ONSITE SEWAGE DISPOSAL SYSTEM

From: Silvast, Zackary
Sent: Tuesday, July 19, 2022 12:08 PM
To: Tony Fertitta
Cc: Bernard, Dana; Williams, Jeffrey
Subject: Regarding OSDS for 12505 Westland Court

SEPTIC PLAN
WESTLAND FARM ESTATES
LOT 14
 12505 WESTLAND COURT

SEPTIC PLAN
WESTLAND FARM ESTATES
LOT 14
12505 WESTLAND COURT
TAX MAP #45 PARCEL: 28
ZONED: RR-DEO
THIRD ELECTION DISTRICT: HOWARD COUNTY, MARYLAND
SCALE: AS SHOWN DATE: MAY 3, 2022

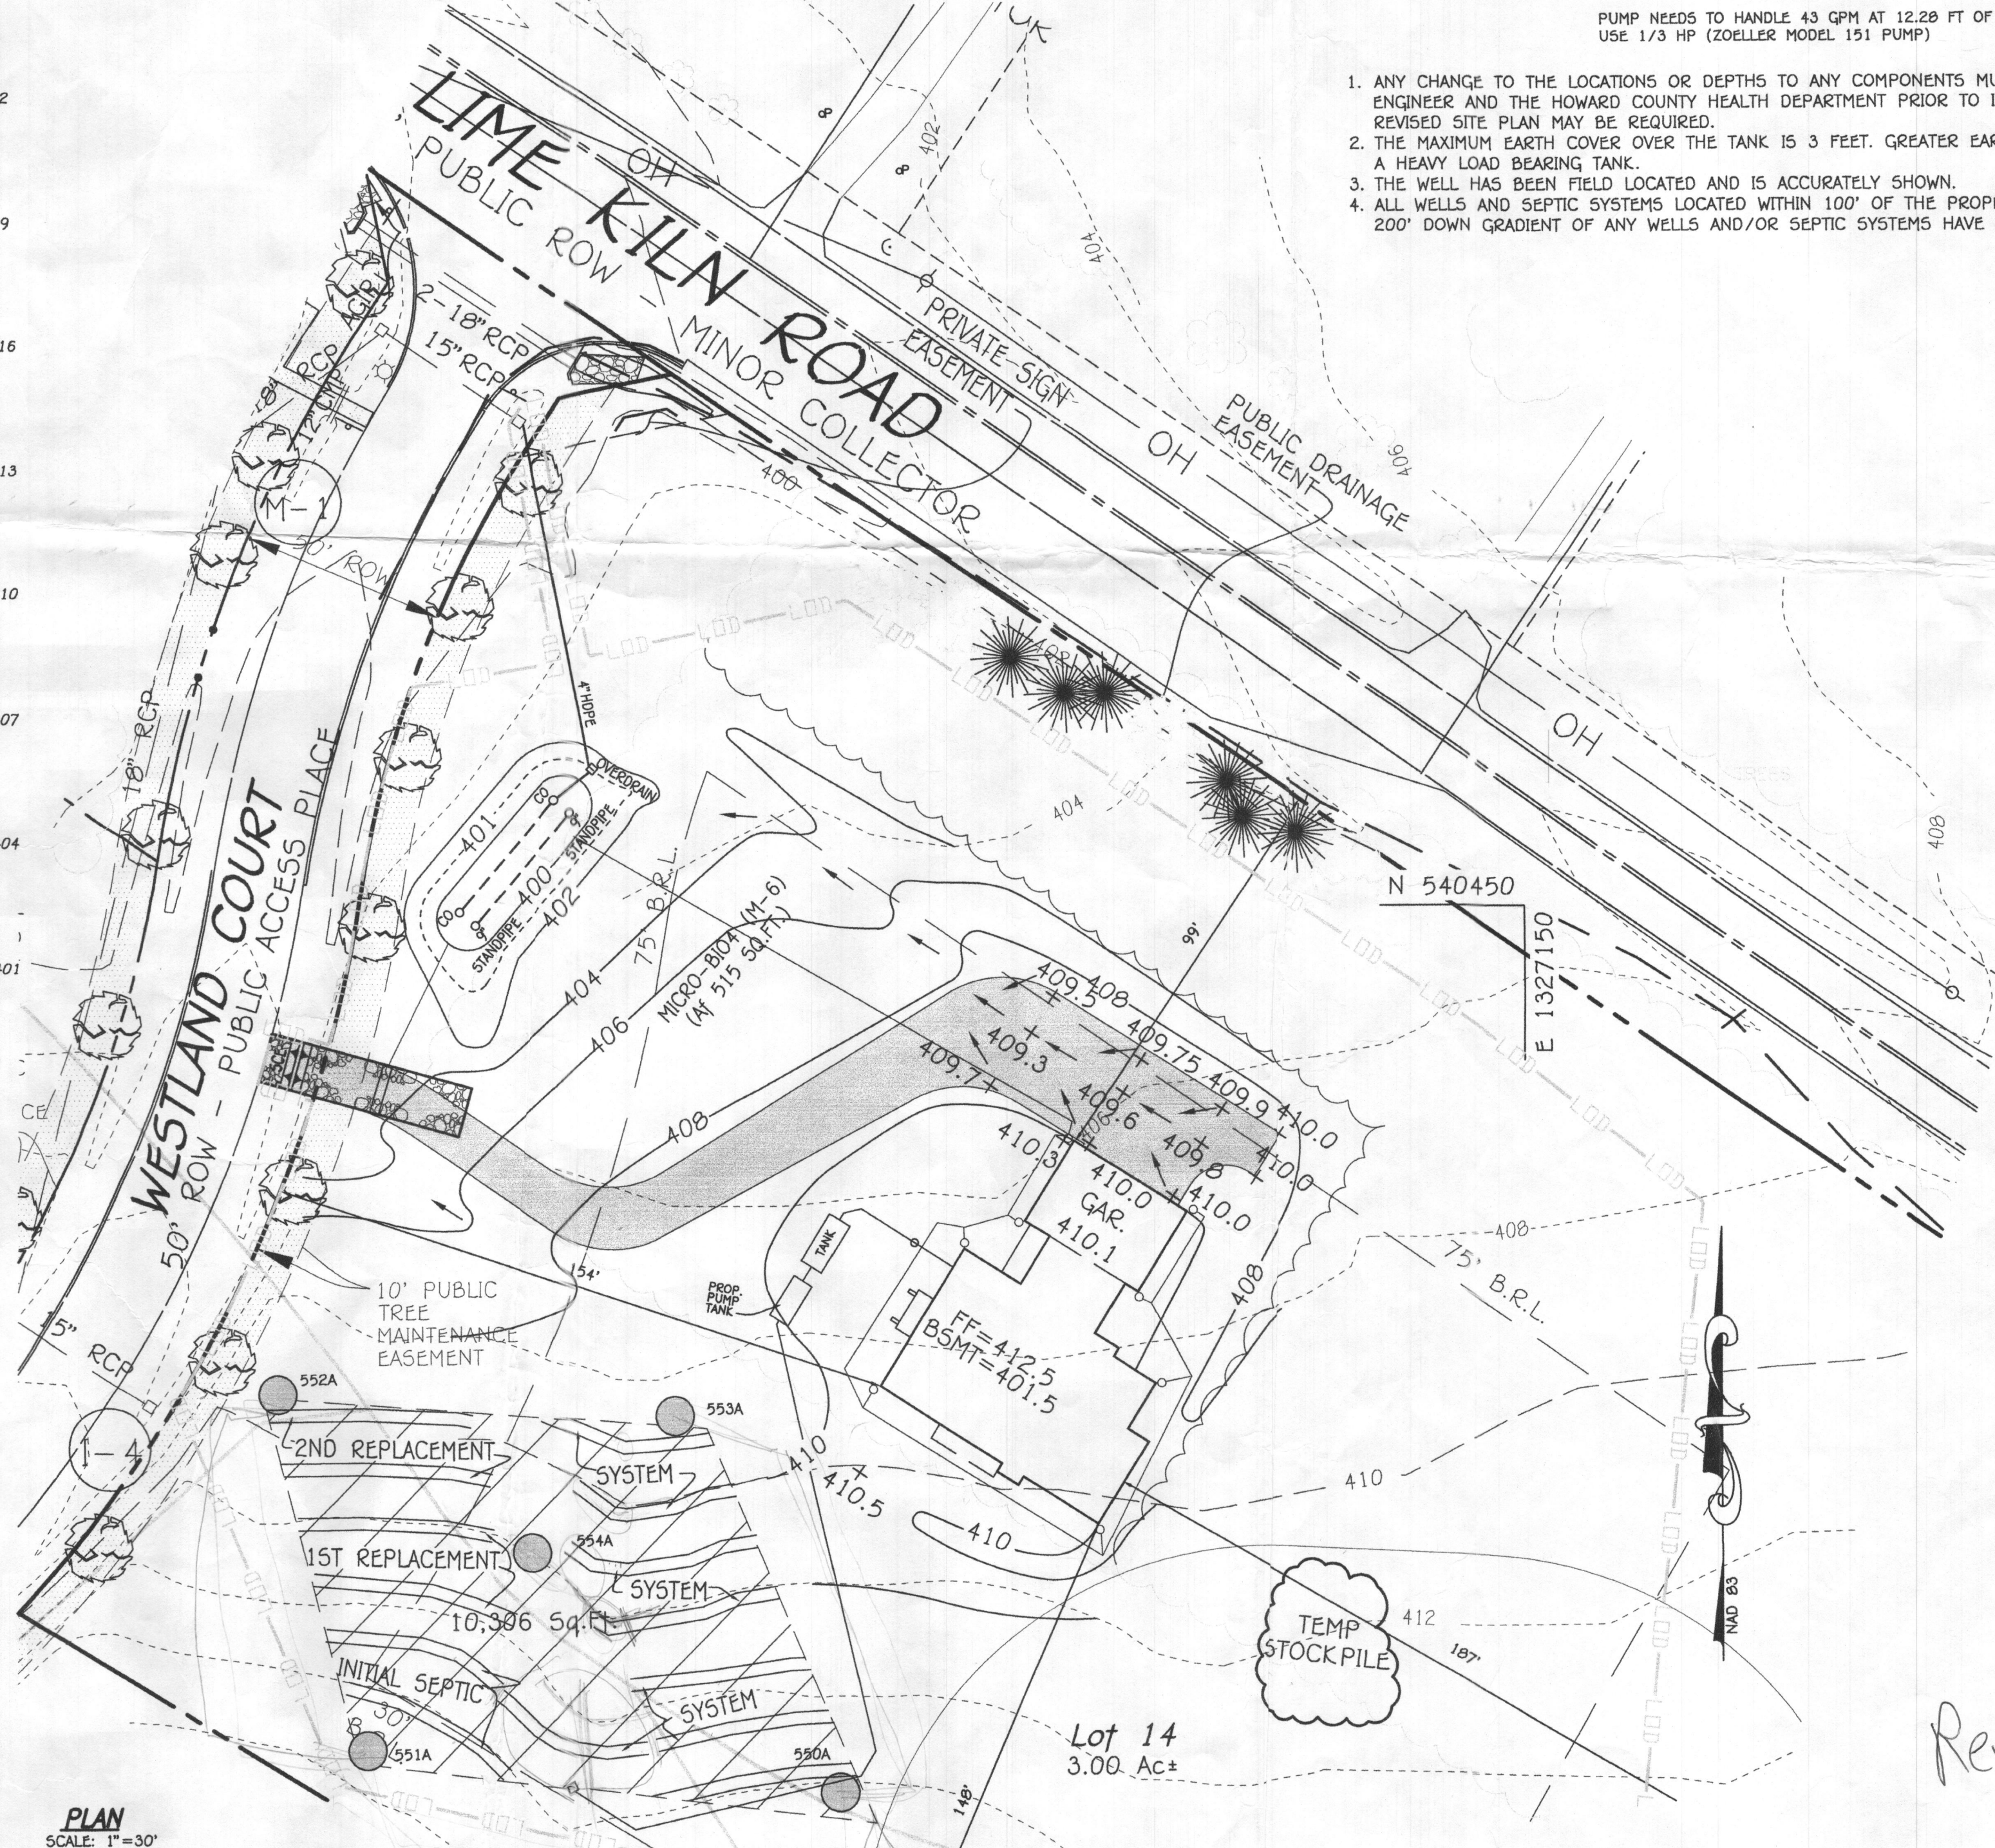
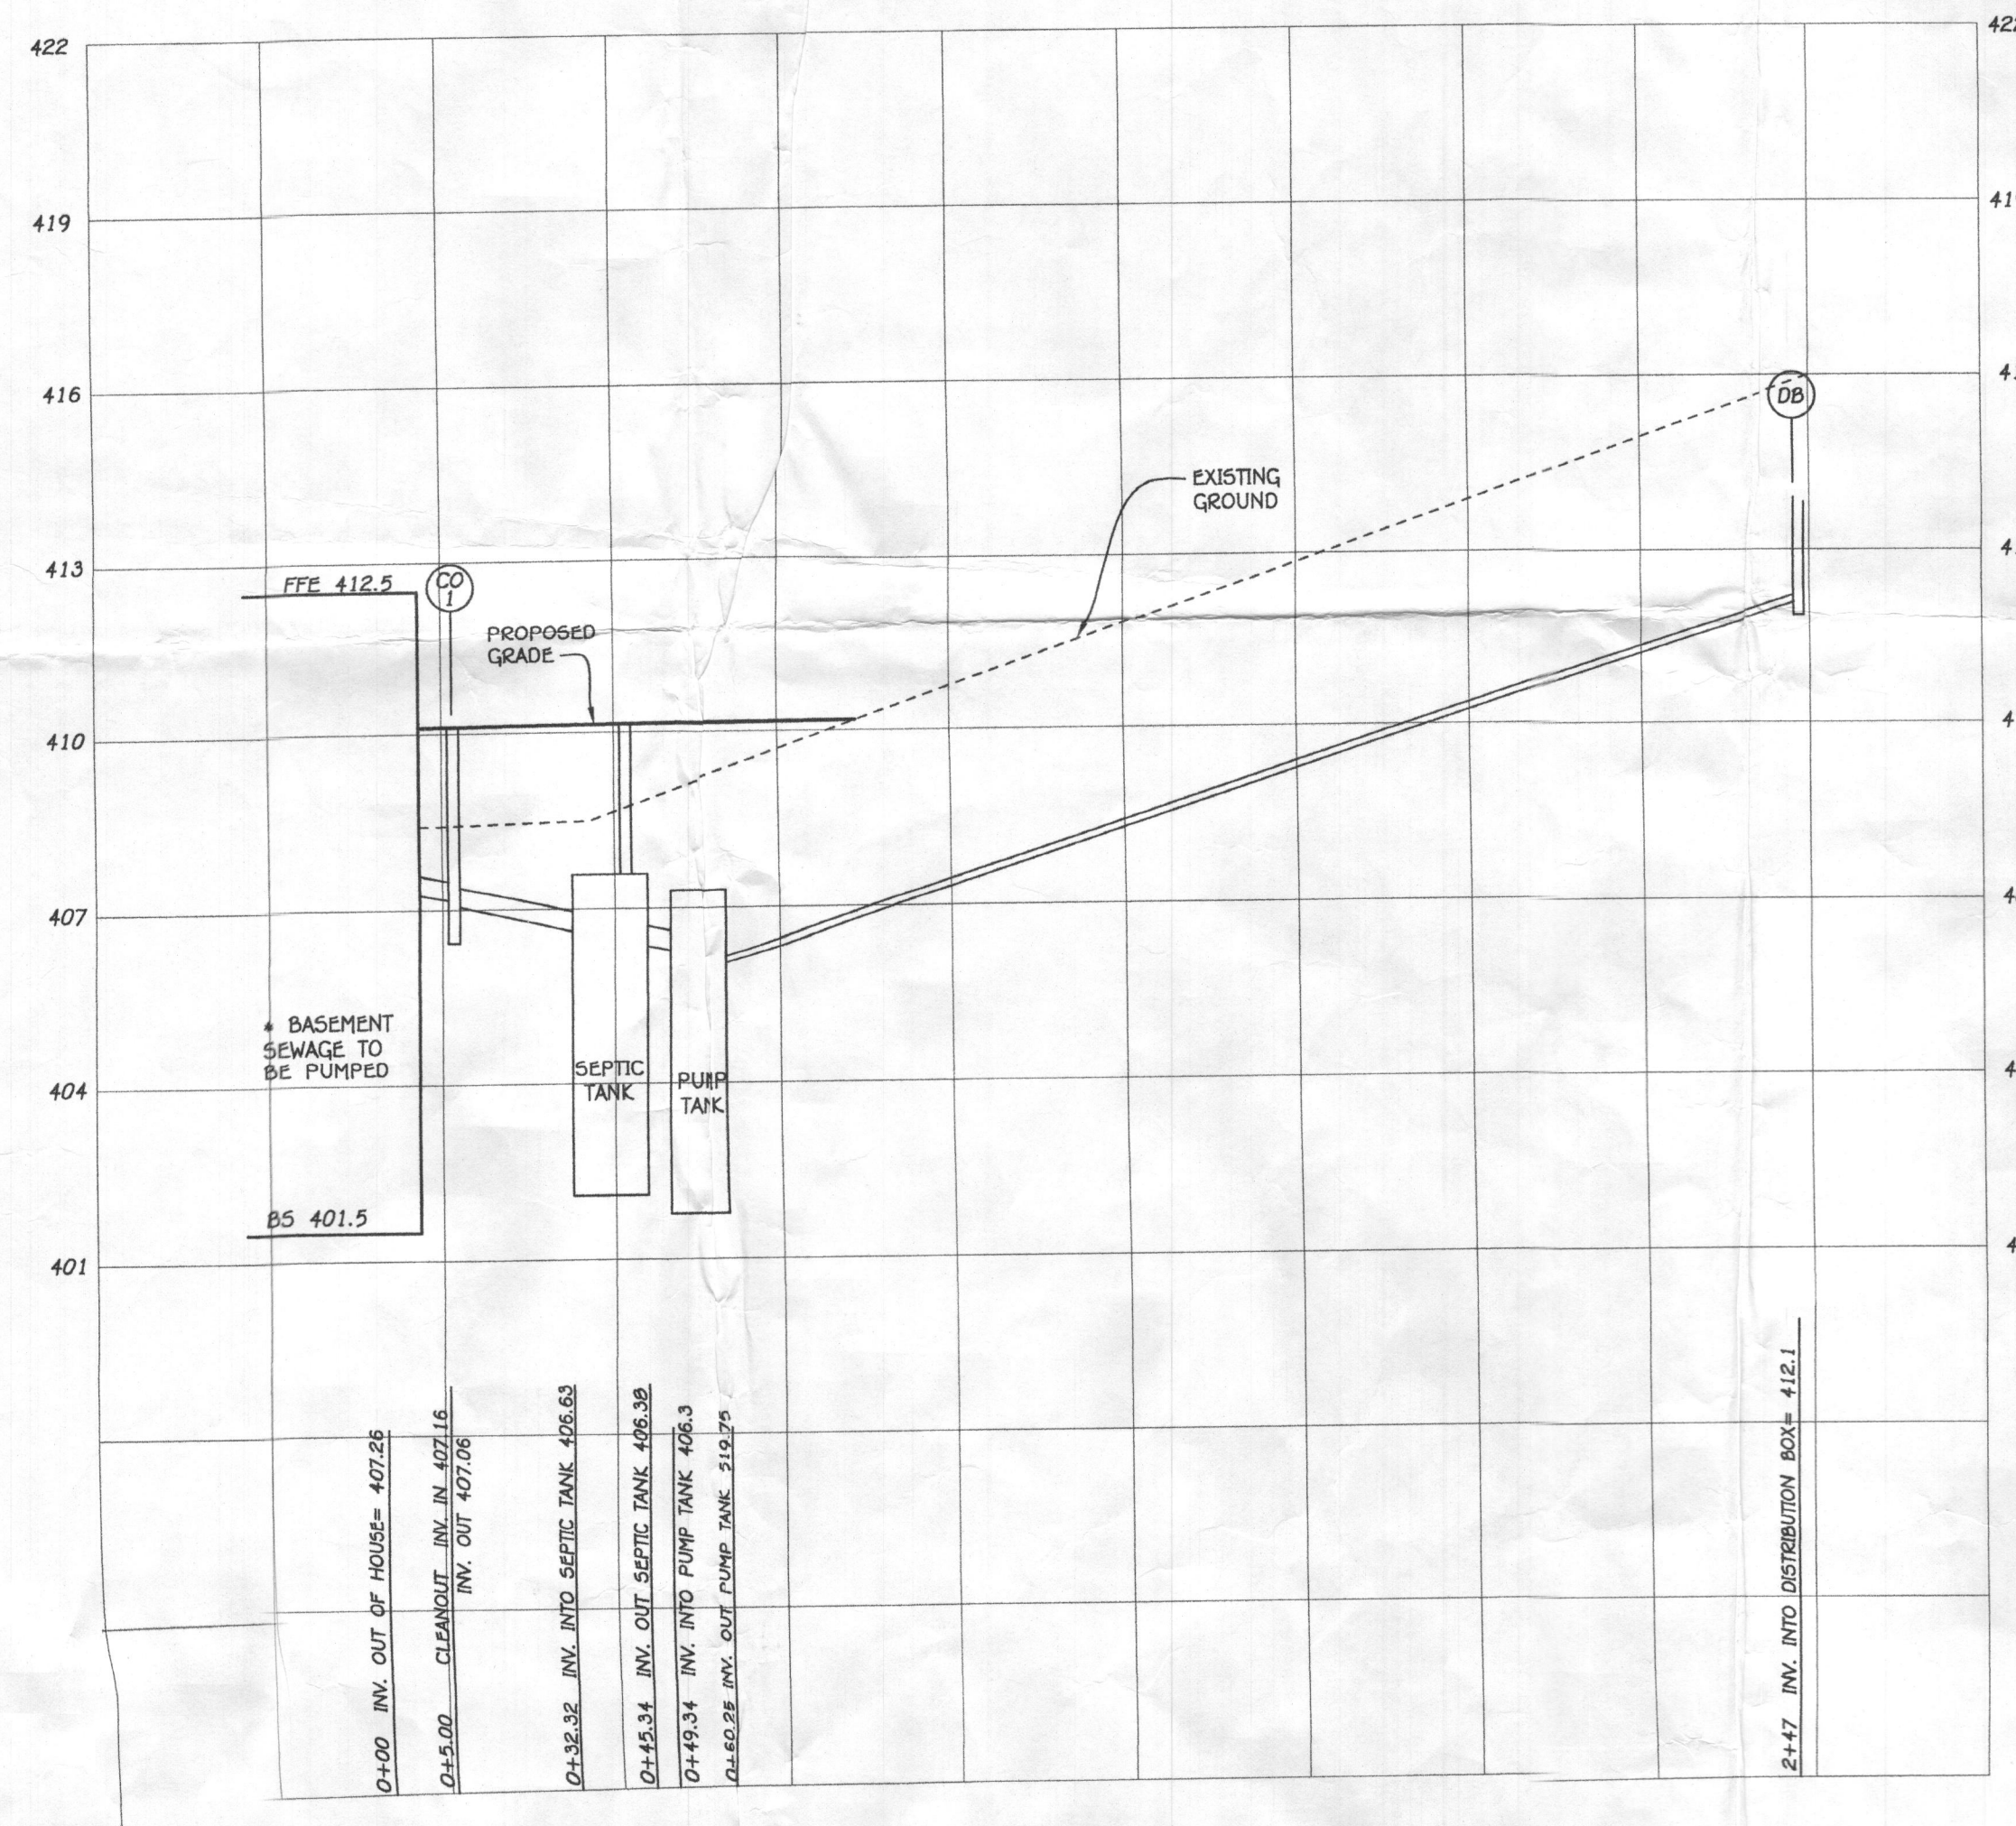
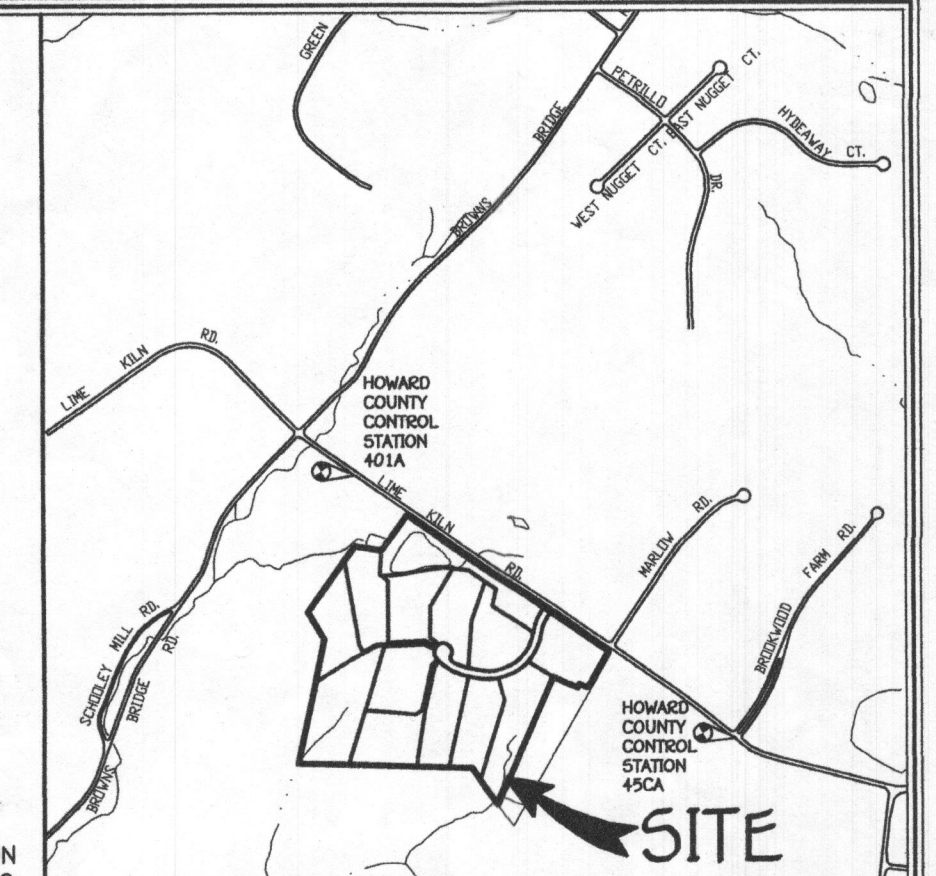
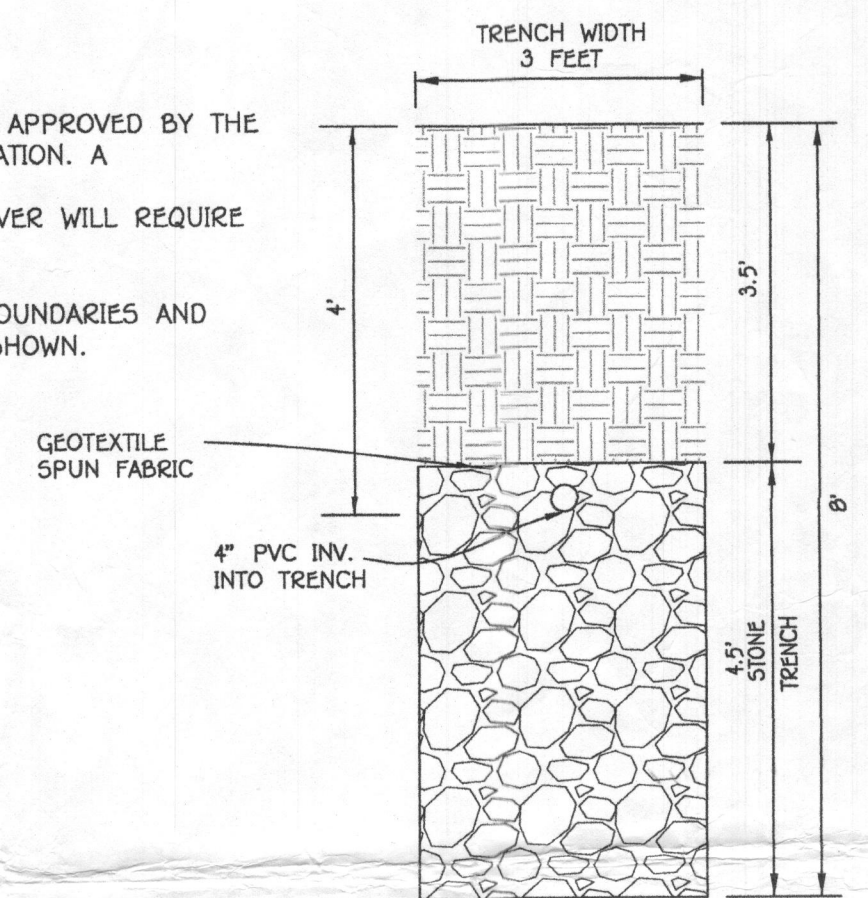
I think the topography is an issue on this site after made my field visit late yesterday afternoon. I would ask that the 10,000 sf SDA be staked out and the grass mowed down. And that 20' circumference around the outside edge of the SDA also be mowed down so we can determine just how the reconfiguration would work. There is a very apparent swale in the SDA area paired with a couple contour tips/toes. I am about 90% sure we will need to adjust the SDA through a new perc certification. I would also like the surveyor to stake out their current drainfield proposal, both the initial and 2 replacements. Thank you all for your cooperation and consideration.

1. **Label 10,000 sf SDA**
2. **Label 2000 GAL septic tank**
3. **Label 1500 GAL pump pit**
4. **Label all the trench lengths.**
5. **Fix the layout of the three systems. You're showing one trench going across the whole SDA.**

- a. You must fix the orientation to not make the curves in the pipes so severe.
 - 1. I understand getting the pipes on contour but these bends are too severe.
- b. A portion of the SDA and property should not be cut off to where the pipe is not visible.
- c. Overall, I should be able to decipher which trenches go with which system: as in initial, 1st replacement, or 2nd replacement.

Attached is a new layout for the Initial trenches. If you ok with this layout I will send paper copies in.

1. **Label 10,000 sf SDA**
The sda label is in the middle of the sda 10,306 sq.ft
2. **Label 2000 GAL septic tank**
Is labeled on the tank detail
3. **Label 1500 GAL pump pit**
It's a 2000 gal tank and is labeled on the tank detail

4. **Label all the trench lengths.**
I have the trench lengths in the sewage disposal system data (Initial system 6 trenches)
5. **Fix the layout of the three systems. You're showing one trench going across the whole SDA.**
Those are 3 trenches in a row so we have equal lengths it has 2 breaks in it 3' apart spacing

- a. **You must fix the orientation to not make the curves in the pipes so severe.**
 1. **I understand getting the pipes on contour but these bends are too severe.**
We draw them to match with the understanding that field adjustments are made.

- b. **A portion of the SDA and property should not be cut off to where the pipe is not visible.**
Not sure what you looking at all of the sda is shown on the plan

- c. **Overall, I should be able to decipher which trenches go with which system: as in initial, 1st replacement, or 2nd replacement.**
All trenches are labeled as to the Initial system, 1st replacement system and 2nd replacement system with leaders pointing to them.
